Page #4

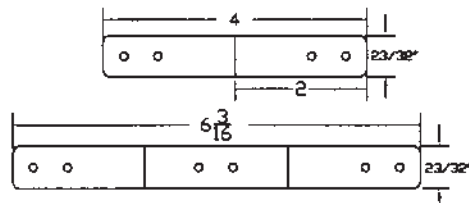
1. Changed the bulkhead corner tabs to make them easier to install.

- (2) TYPE 2 RIVETS PER FLANGE  
.025 6061T6
- (10) CORNER TABS REQUIRED
  - (4) 4" TABS BULKHEAD "B"
  - (2) 6 3/16" TABS BULKHEAD "B" (TOP CORNERS)
  - (4) 4" TABS BULKHEAD "E"
